TECHNICAL REVIEW OF DRAFT ENVIRONMENTAL IMPACT STATEMENT

Long Island Rail Road Expansion Project Villages of Floral Park, New Hyde Park and Garden City, New York

VERTEX Project No: 43124
February 14, 2017

Figure 3.1 – 115 New Hyde Park Road

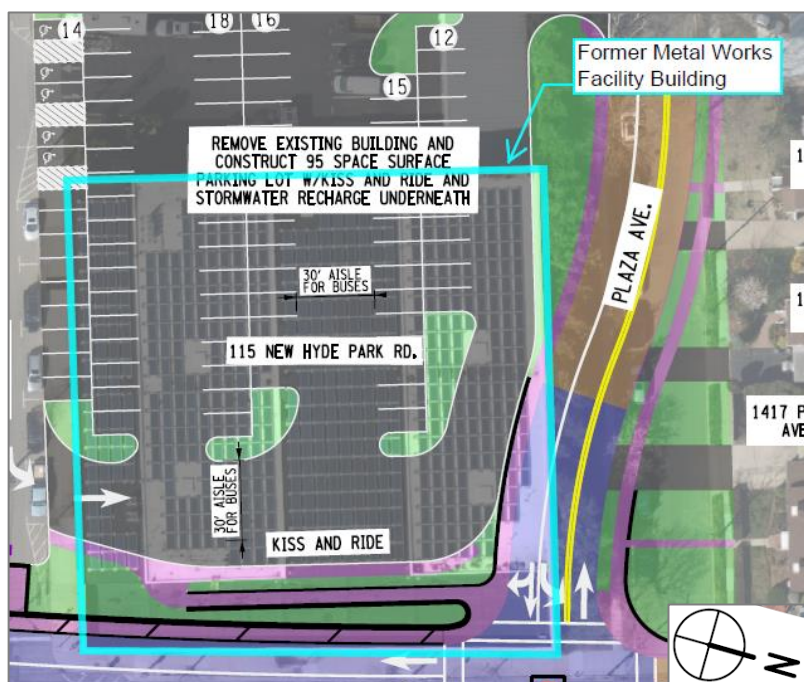
- **New Hyde Park Road Grade Crossing Elimination (New Hyde Park)** – One of the design options for the grade crossing elimination at New Hyde Park Road (Option 1) includes the acquisition and full demolition of the self-storage building at 115 New Hyde Park Road beginning in November 2017 according to Chapter 13 of the DEIS. Once the structure is demolished, an excavation to a depth of up to 31 feet will be completed at the parcel, planned to begin in spring

2018. According to Chapter 8 of the DEIS, 115 New Hyde Park Road is a Category B site (#156) due to the historic presence of a metal works facility at the parcel, as depicted in the 1950 through 1969 Sanborn Fire Insurance Maps. According to the Nassau County Land Records Viewer, the current self-storage structure at the parcel was constructed in 1946 and, therefore, present at the time of metal works operations. Given the absence of reported releases identified for the parcel address in the DEIS regulatory records search and the presence of the historic structure on the majority of the parcel footprint, it is likely that no significant subsurface investigation and/or excavation has been performed since the cessation of industrial activities at the parcel. However, despite the historical use of the site, no soil or groundwater data for the parcel or surrounding properties was included in the DEIS. An annotated detail from DWG GCC04 (Page 169 of DEIS Appendix 1-A) showing the location of the current building (former metals works facility) in relation to the proposed Project construction plan is provided as Figure 3.1.

According to the DEIS, a subsurface investigation will be conducted at all of the acquisition Category B sites. Even though 115 New Hyde Park Road is stated to be a known acquisition Category B site, there is no information provided to suggest that due diligence activities, including a subsurface investigation, are identified to have been initiated at this parcel. As such, the schedule for the Proposed Project will need to accommodate the due diligence subsurface investigation, regulated building materials (asbestos, lead-based paint, etc.) surveys, the potential incorporation of specific site conditions into a RAP, and the preparation of a CHASP, all before November 2017. These technical and regulatory tasks will need to be complete as will also real estate negotiations and the relocation of the current self-storage customers, etc. Since the current building covers nearly the entire parcel footprint, any pre-demolition subsurface investigation would likely be limited in nature and would need to be supplemented with post-demolition assessment between the completion of building demolition at the end of 2017 and the start of earthwork in early spring 2018. Even if all of these activities were able to be conducted in time to meet the stated schedule,

there would likely be limited time allowed for the surrounding community to be able to review and comment on a RAP and CHASP prior to implementation (As noted earlier, this type of information should have been included in the DEIS). Such review would be needed to allow the neighboring residents and business owners to assess whether concerns they might have including the migration of metals-impacted dusts and the spread of metals-impacted soils by truck tires are properly anticipated and addressed in the construction plans.

Figure 3.3 – Plainfield Avenue Bridge

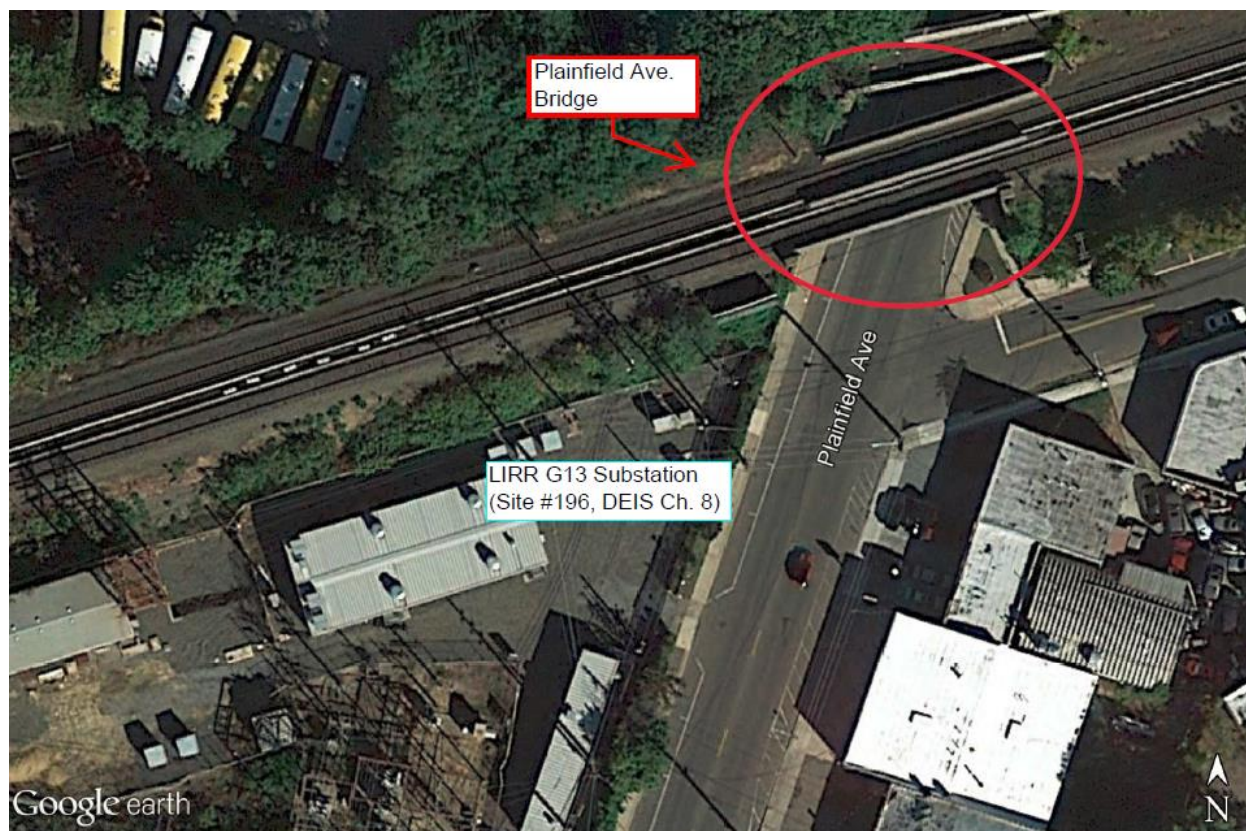
- **Plainfield Avenue Bridge (Floral Park)** – According to Appendix 1-A of the DEIS, an additional bridge over Plainfield Avenue will be retrofitted to accommodate the planned third track. As shown in the Appendix for Chapter 8 of the DEIS, this bridge is located immediately adjacent to site #196, which is the existing Floral Park LIRR G13 substation that is not to be altered during the construction of the Proposed Project. According to the DEIS, site #196 is the subject of subsurface releases being actively addressed by LIRR as part of the Voluntary Cleanup Program. In this case, it is likely that subsurface investigation data in the vicinity of this location associated with the Proposed Project is available for review, and the specific risks to the Village can be determined and mitigated in some manner; however, the DEIS does not include any of this data and this evaluation is therefore not provided in the DEIS. The location of the substation site in relation to the Plainfield Avenue bridge is shown on Figure 3.3.

Figure 6.2

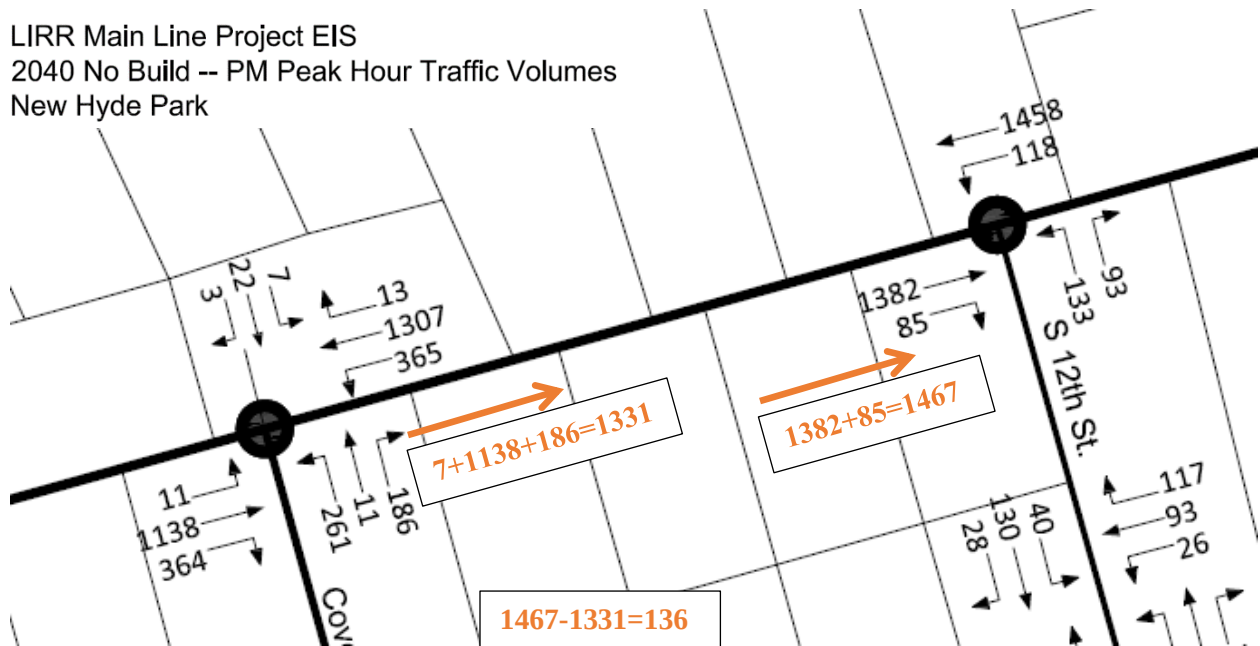
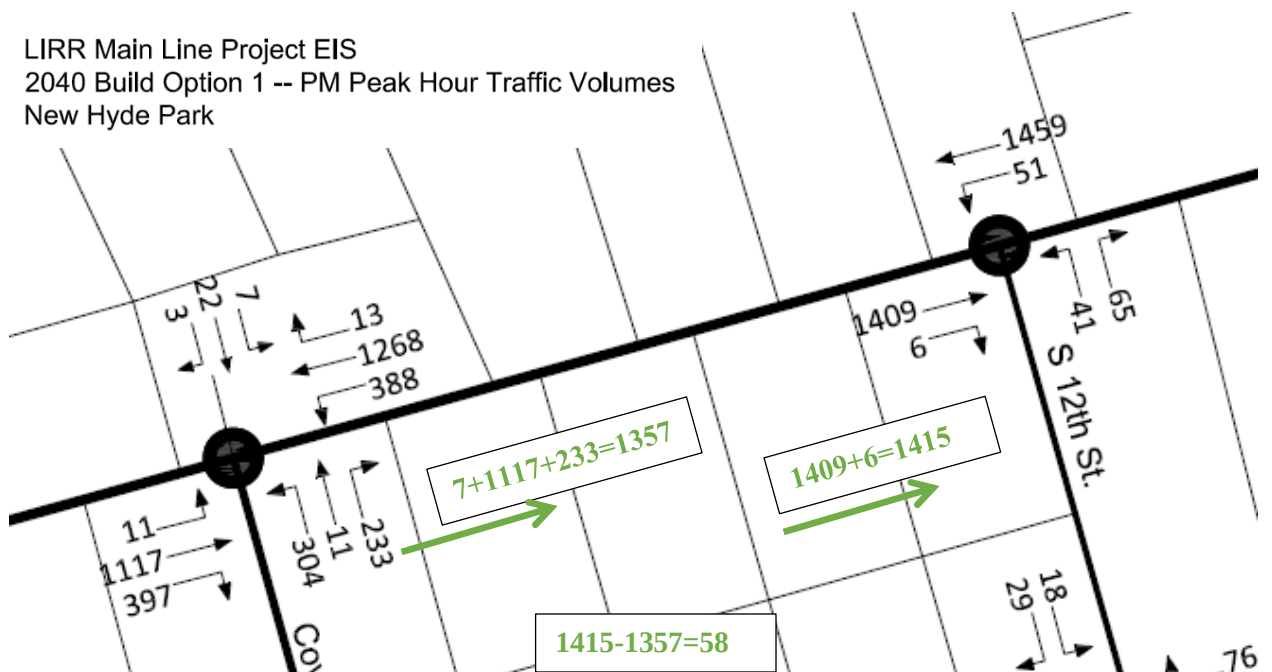
There appears to be major discrepancies in the routing of vehicles when comparing the No-Build Condition to Build Condition peak-hour volumes for the New Hyde Park volume figures (i.e., Pages 12 vs. 19 and 13 vs. 20 of Appendix 10 of the DEIS). Volumes frequently do not track between intersections with vehicles getting 'lost' between study locations. For instance, as indicated in Figure 6.2 and Figure

6.3 the 2040 No Build PM Peak Hour Condition volume figure indicates that 1,331 vehicles leave the intersection of Jericho Turnpike and Covert Ave traveling eastbound ($7+1138+186$) and 1,467 vehicles ($1382+85$) arrive at Jericho Turnpike and South 12th Street eastbound for a net difference of 136 vehicles. In the 2040 PM Option 1 Build Condition, volume figure, the net difference between intersections decreases to 58. ($1117+233+7-1409-6=58$). Either there are numerical errors in the calculations which must be rectified to ensure the conclusions made are valid or traffic is projected to utilize the side streets between Covert Ave and South 12th Street, necessitating the need for additional study locations.
